## ADDENDUM NO. 2

**PROJECT NAME:** Wick Alumni Center Life Safety & HVAC Improvements  
**UNL PROJECT NUMBER:** C120P021  
**BID INVITATION NUMBER:** 2222-13-7200

**CONSULTANT:** Farris Engineering  
**ADDRESS:** 818 P Street, Suite 100

**DATE OF ISSUANCE:** September 11, 2013  
**DATE OF BID OPENING:** September 18, 2013

**SHEET NO**  
**MD2-1**

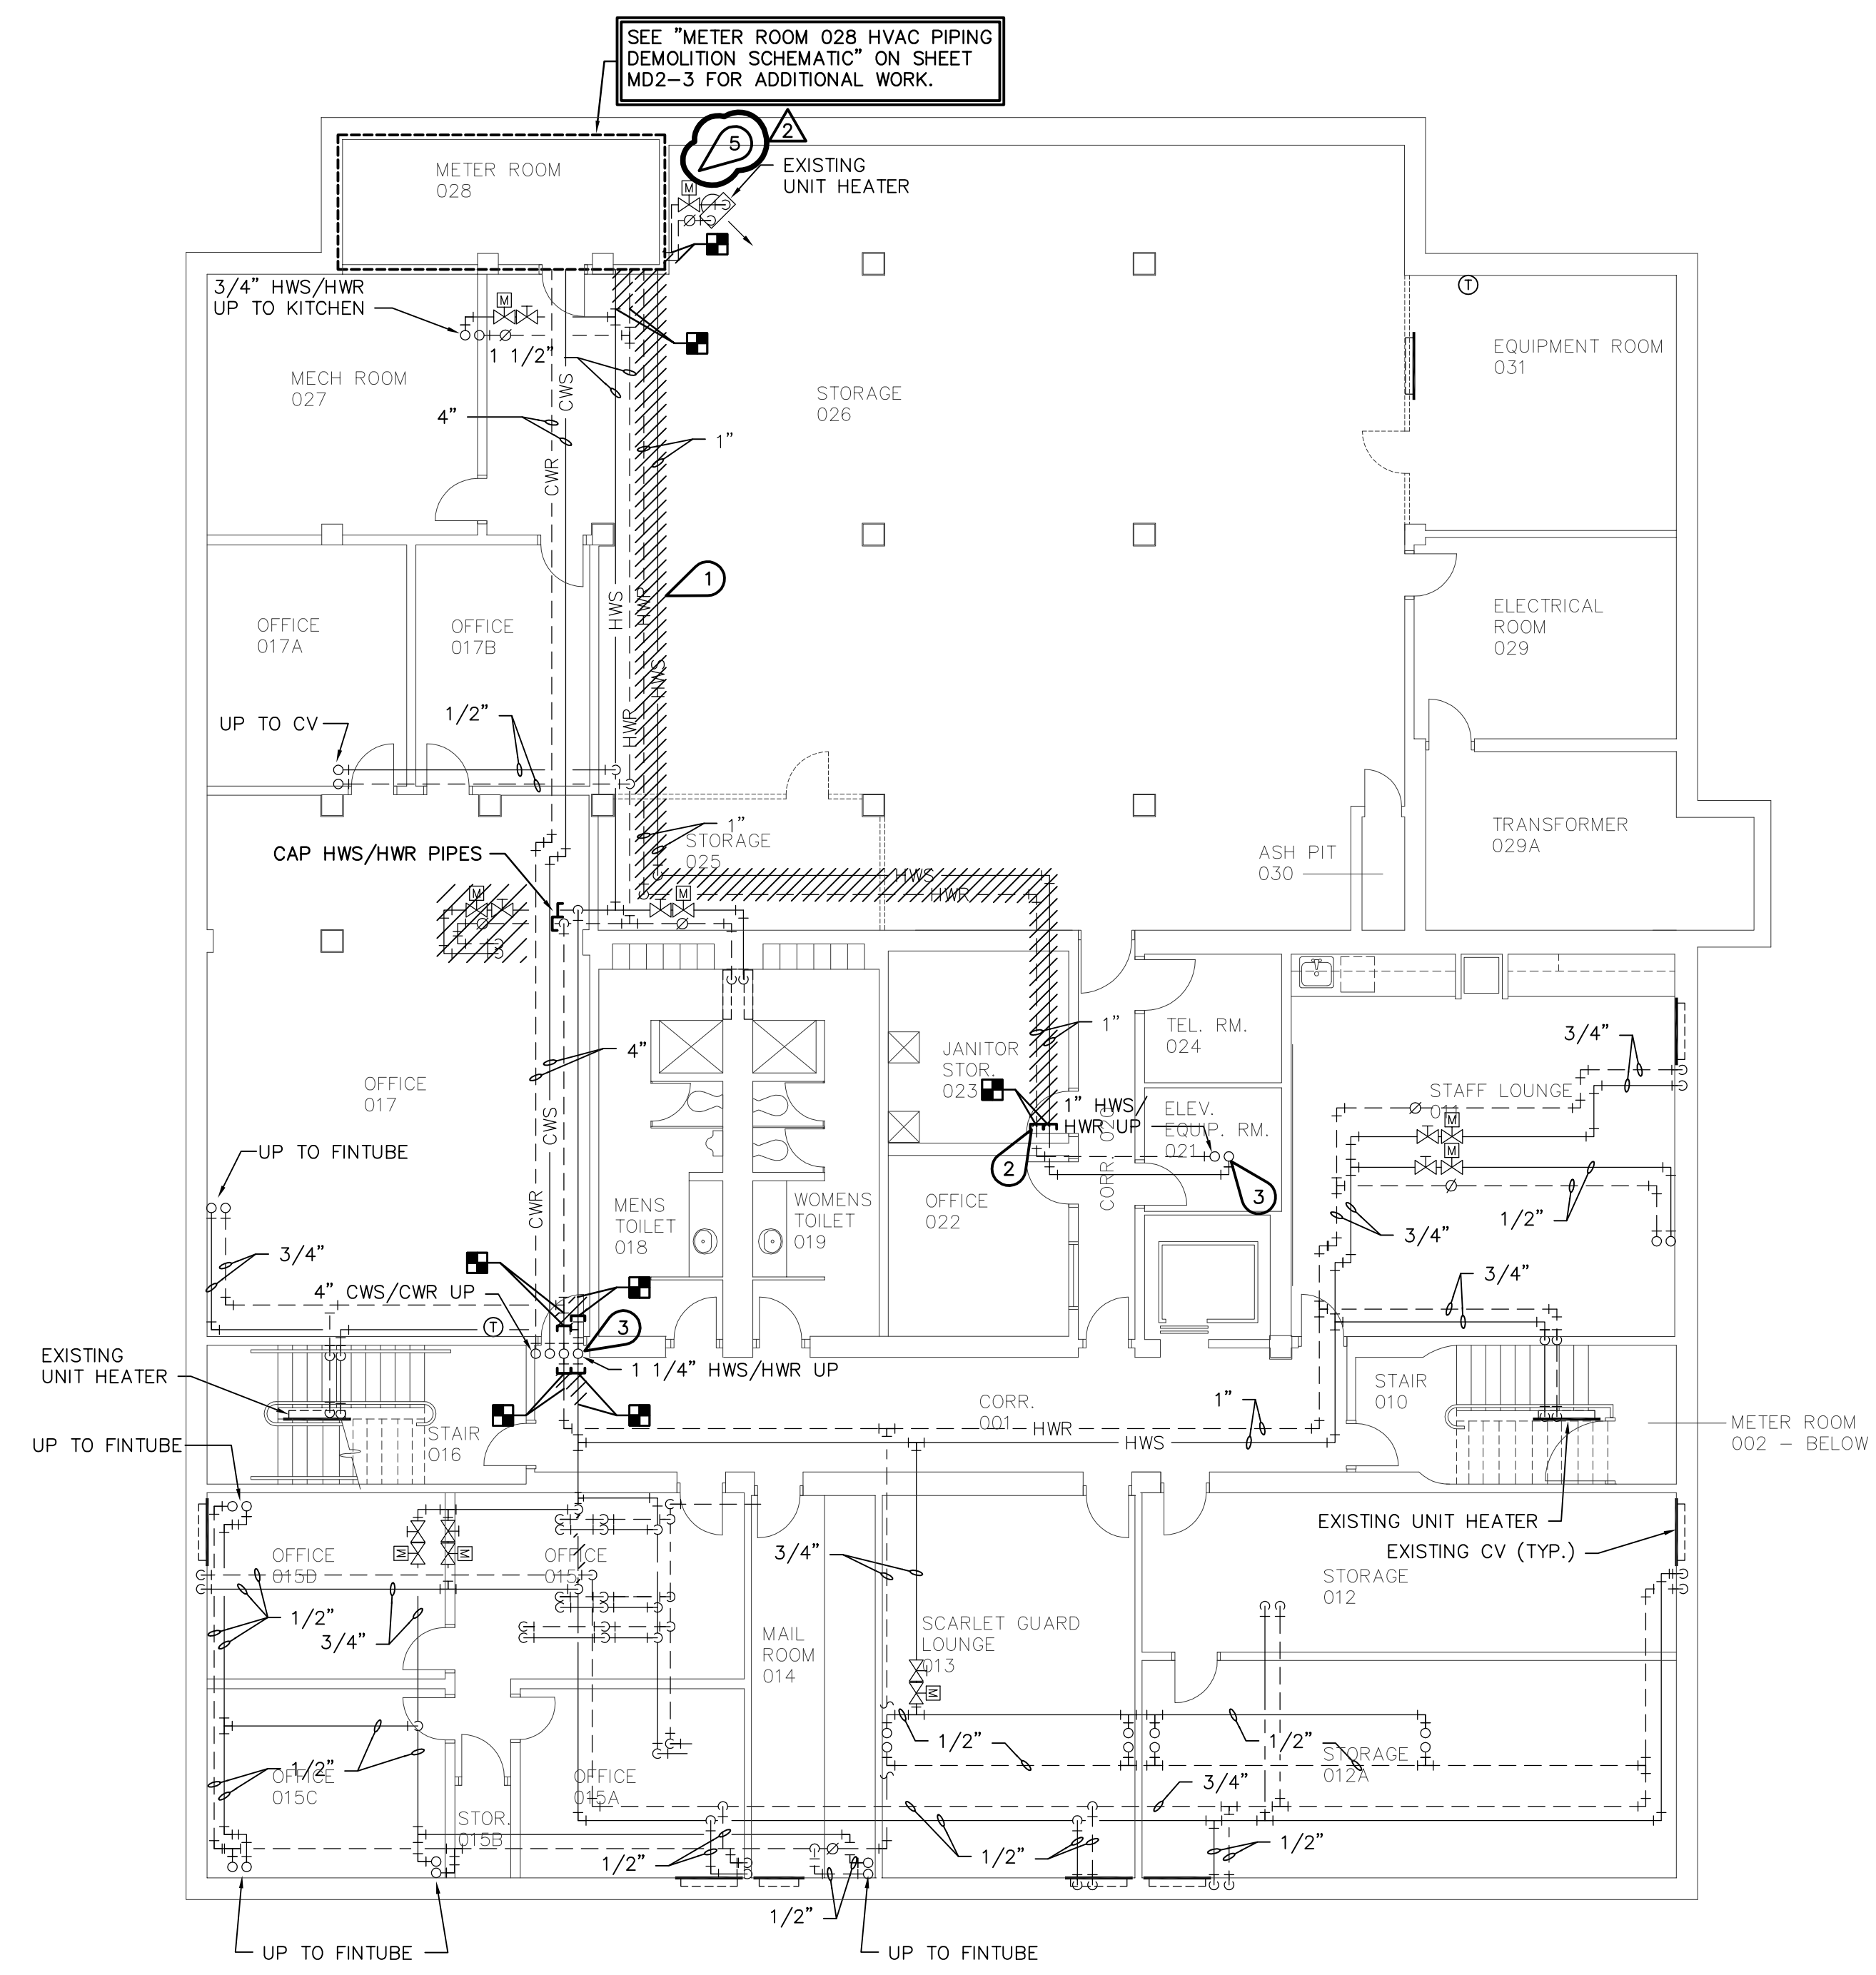
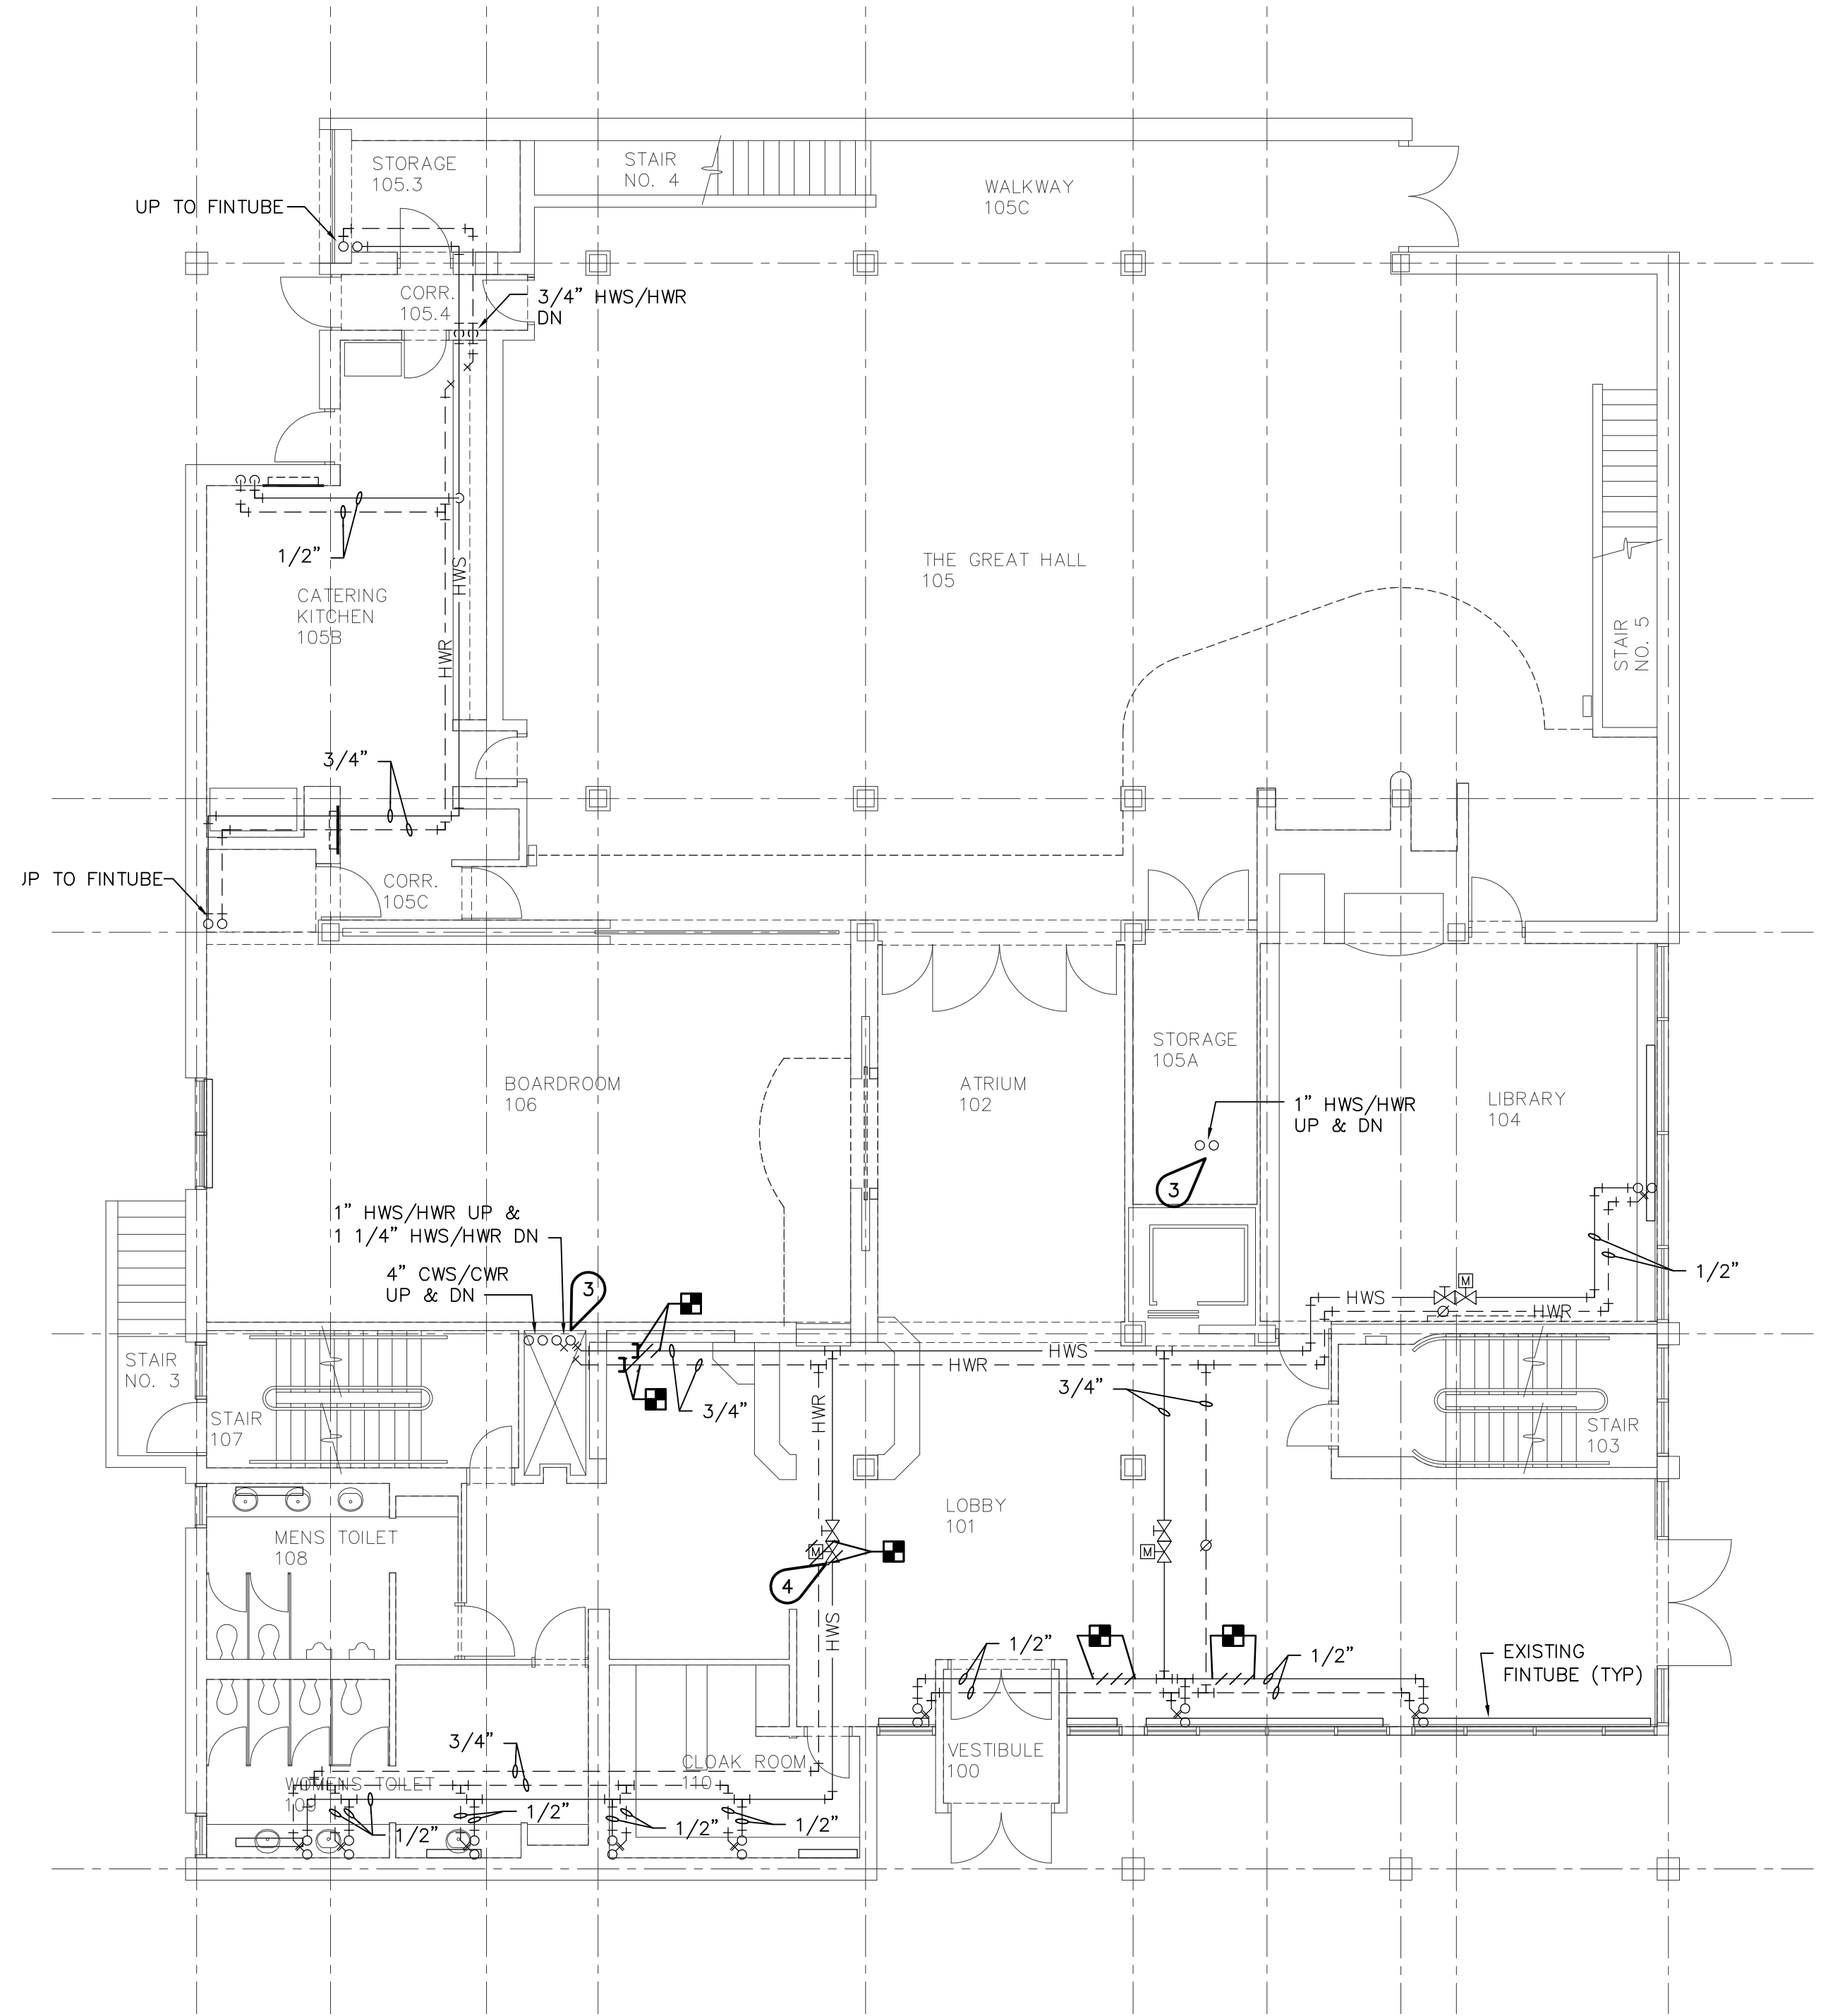
1. This sheet has been reissued in its entirety as a part of Addendum No.2.
2. Mechanical Keynote #5 has been added.

SHEET NO  
**MD2-3**

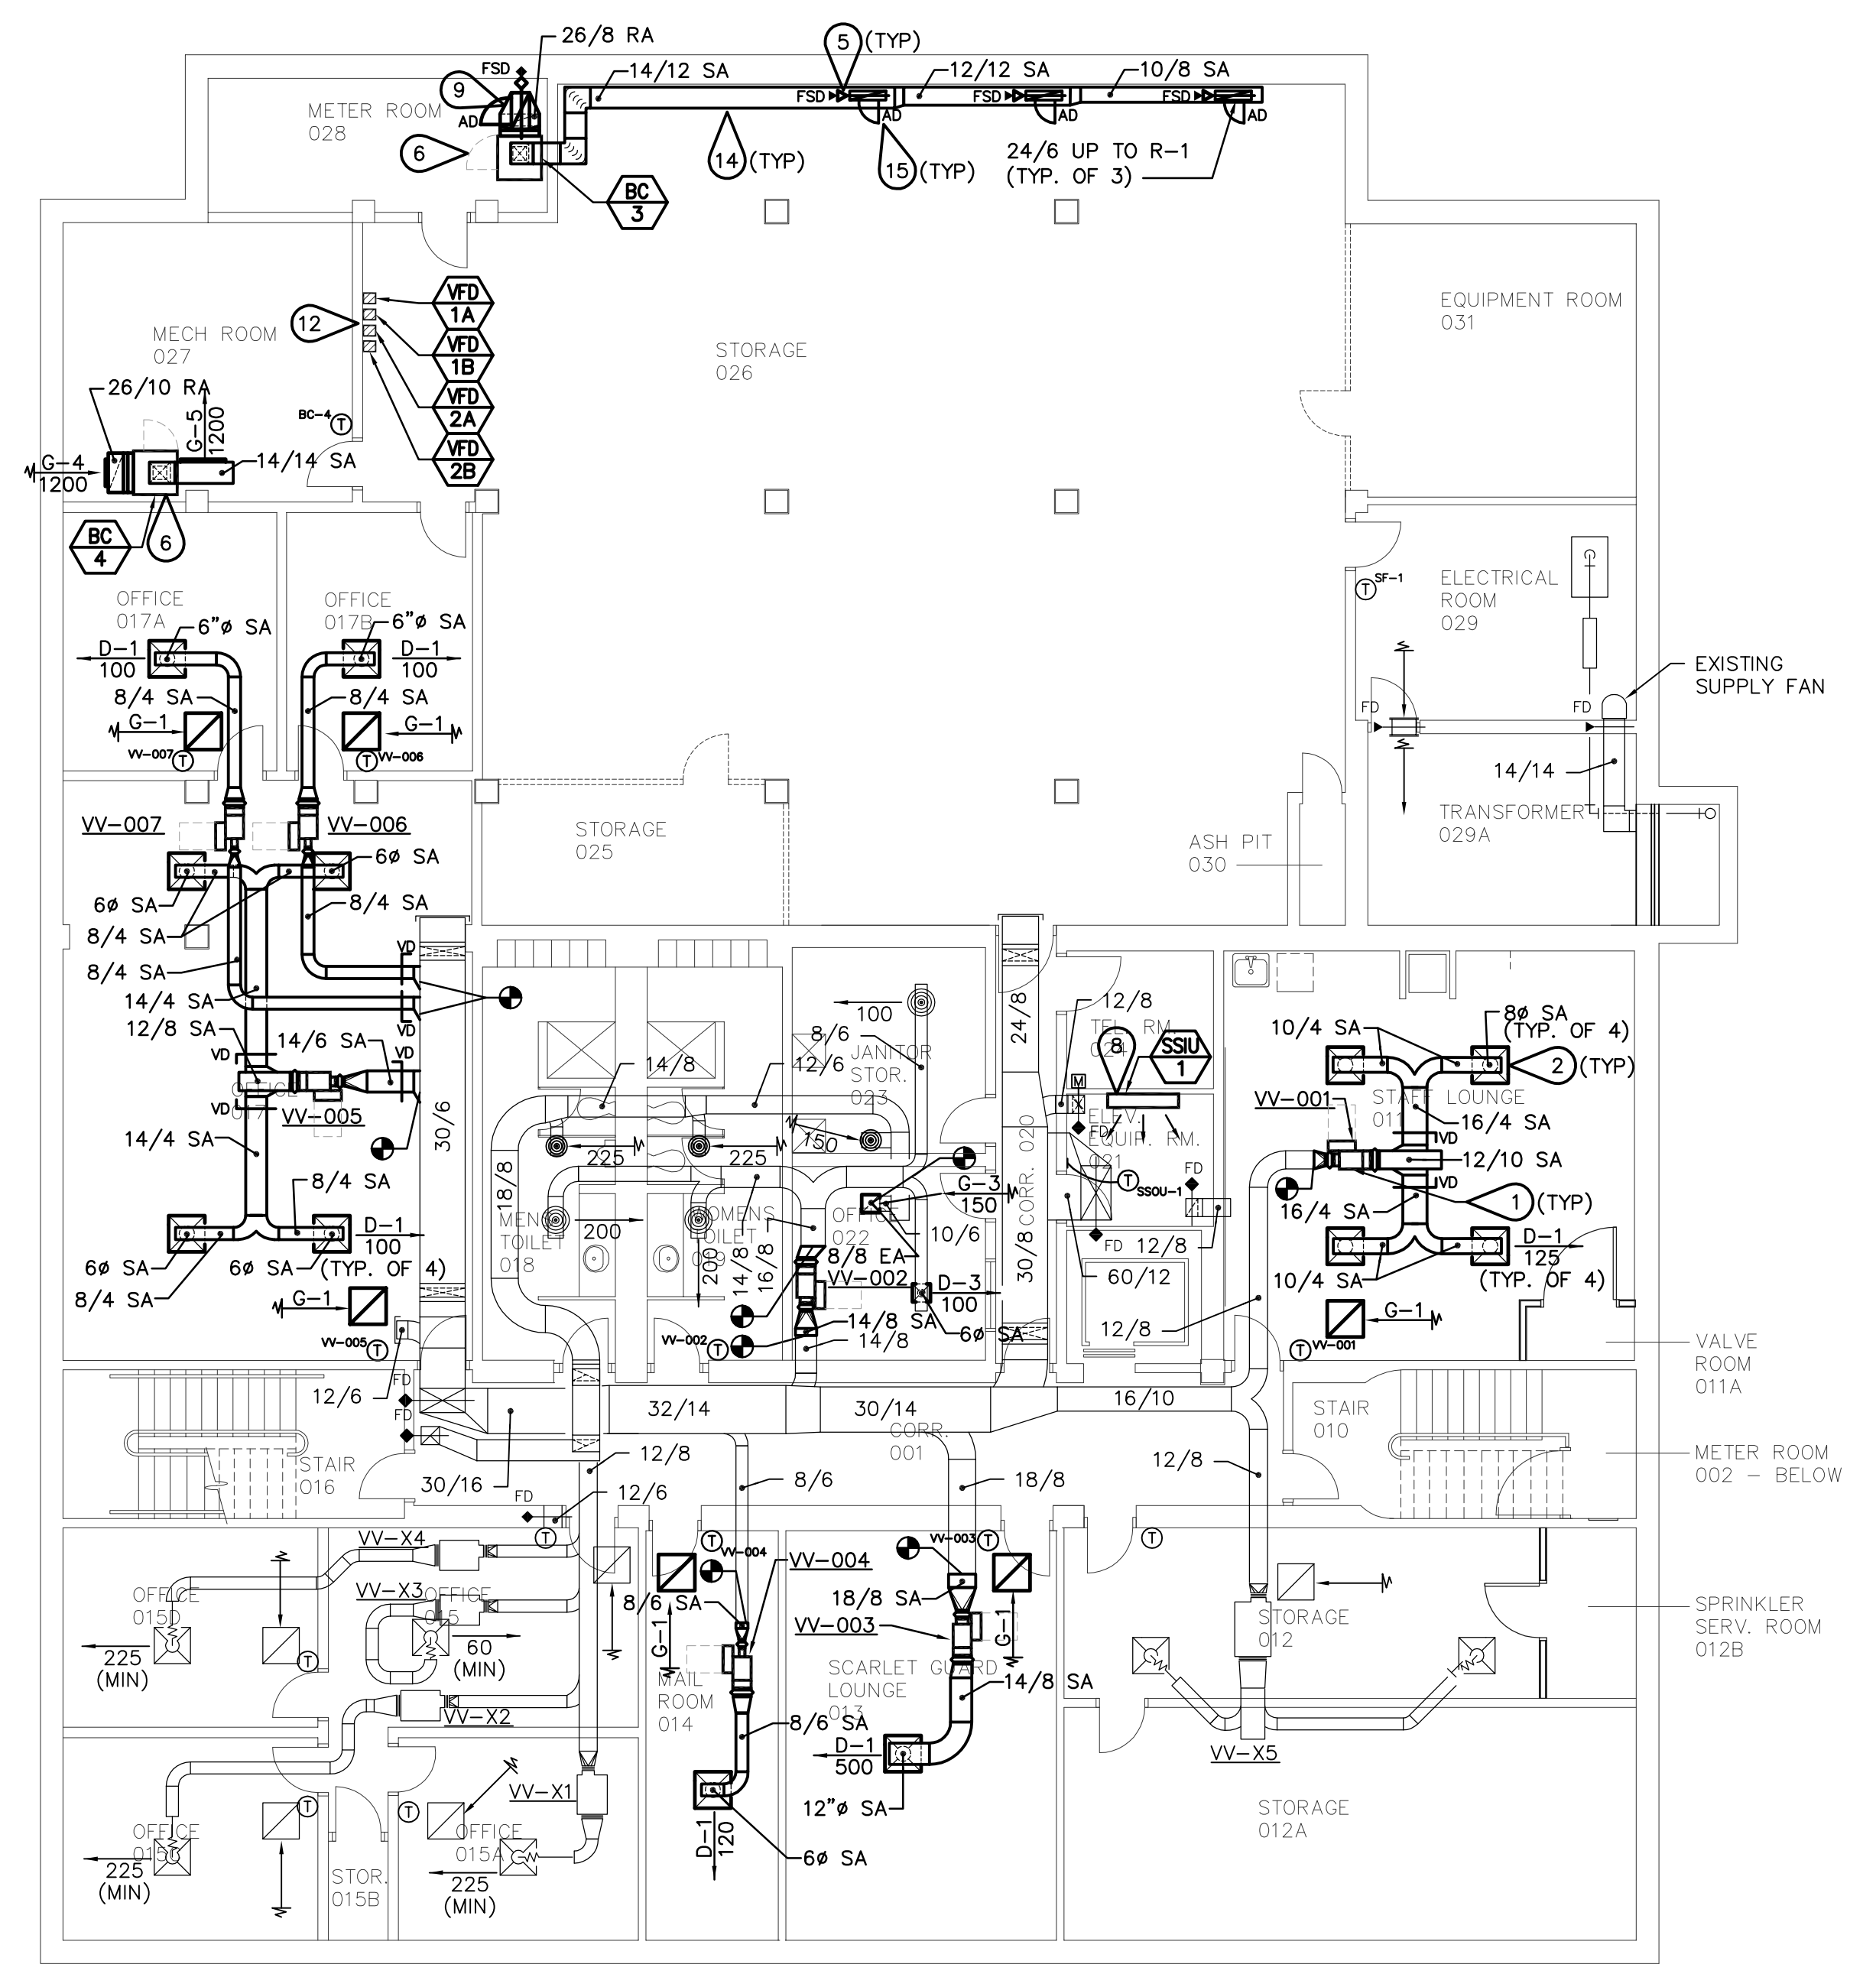
1. This sheet has been reissued in its entirety as a part of Addendum No.2.
2. Mechanical Keynote #8 has been added.
